RE: 1717 Archuleta Dr. NE
1717 Archuleta Dr. NE
Grading and Drainage Plan
Engineer's Stamp Date: 5/24/21
Hydrology File: J23D021

Based upon the information provided in your submittal received 1/4/2022, the Grading & Drainage Plan is **not** approved for Building Permit. The following comments need to be addressed for approval of the above referenced project:

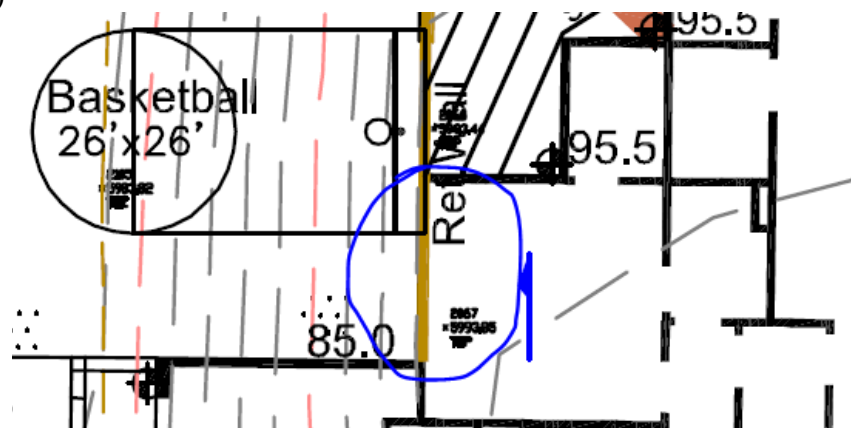
1. Can you please note if this is a stem wall as part of the foundation of the home? (below image)

- i. Please provide top of wall and bottom of wall elevations. Provide a detail please.
2. Please include bottom of wall elevation along the PUE. Provide a cross section/detail showing the PUE and ensure the footing is outside of that.
 3. You are calling out basins, please provide a basin map and clearly show how flow is getting to each proposed pond.
 4. Please clearly label what the required retention volume is needed and what is provided for each basin.
 5. Please include project benchmark and datum
 6. Please include the FIRM.
